Source: TSG CN WG 2
Title: Separated CRs for R99 Work Item CAMEL3
Agenda item: 7.2
Document for: APPROVAL

SPEC	CR	REV	TDoc	PHAS	SUBJECT	CAT	OLD VER
23.078	239		N2-000566	R99	Check_Gap_Criteria correction	F	3.6.0

Subject: **Check_Gap_Criteria correction**

Figure 4.67: Procedure Check_Gap_Criteria (sheet 1)

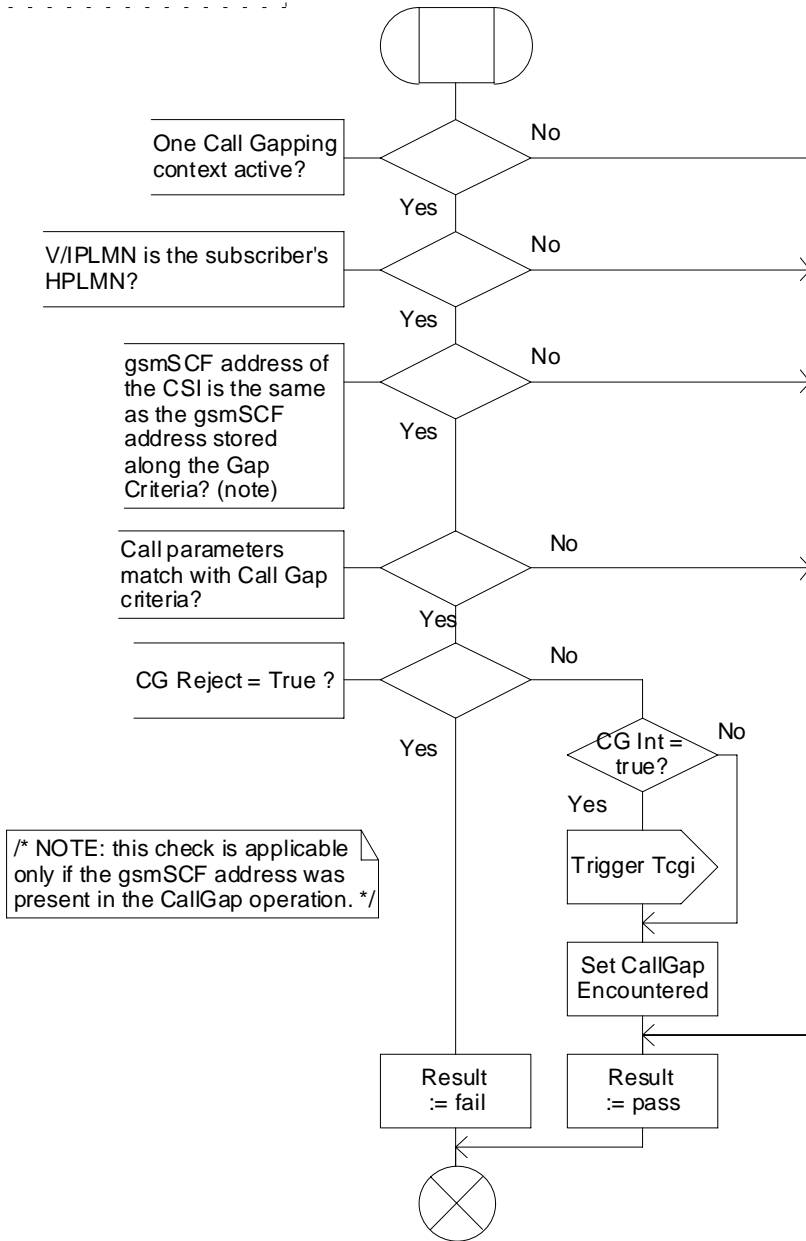
Reason for change: There is an inconsistency between 22.078 Congestion control requirement and 23.078 implementation of the Procedure Check_Gap_Criteria. The requirement in stage 1 states that the congestion control shall effects to the '...interrogations from a V/IPLMN, when the V/IPLMN is the subscriber's HPLMN' and the stage 2 Procedure Check_Gap_Criteria checks 'gsmSCF address of the CSI belongs to the same PLMN?'. In N-CSI case the stage 2 implementation affects to the visited subscribers but stage 1 requirement does not affect. The proposal in this CR is to change the stage 2 implementation according the stage 1 requirement.
